# Instruction Sheet

**IS-03108**

## ADDITION OF RESISTORS ON HALOGEN LOW BEAM HEADLIGHTS CIRCUIT

Applicable for H3 coaches and VIP series vehicles with halogen type low beam headlights from vehicle 2PCH33492<u>3</u>101<u>4477</u> up to 2PCV33497<u>4</u>101<u>4866</u>. Reference ECN2003108

FIGURE 3

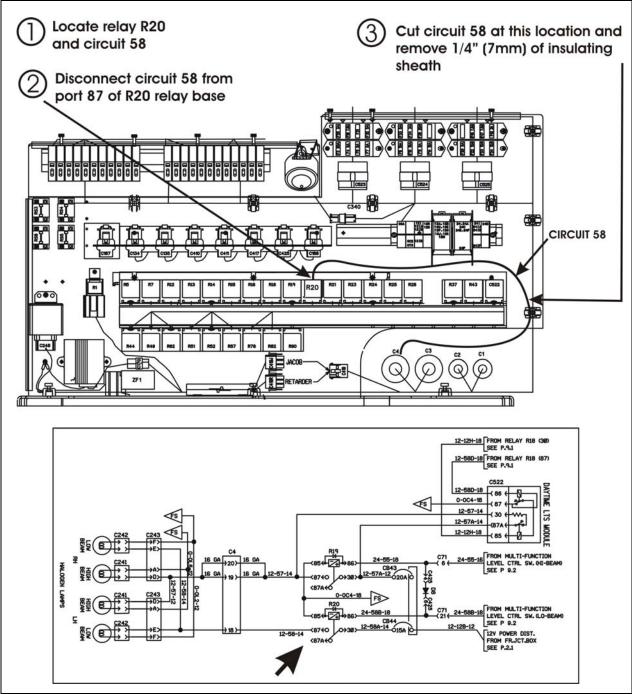
- 1. Confirm that your low beam headlights are of the halogen type. Halogen low beam headlights do not require ballast to function (see figure 2). If there is a ballast, your low beam headlights are of the xenon type and this bulletin is not applicable to your vehicle.
- 2. Carry out steps of figure 3 & 4.
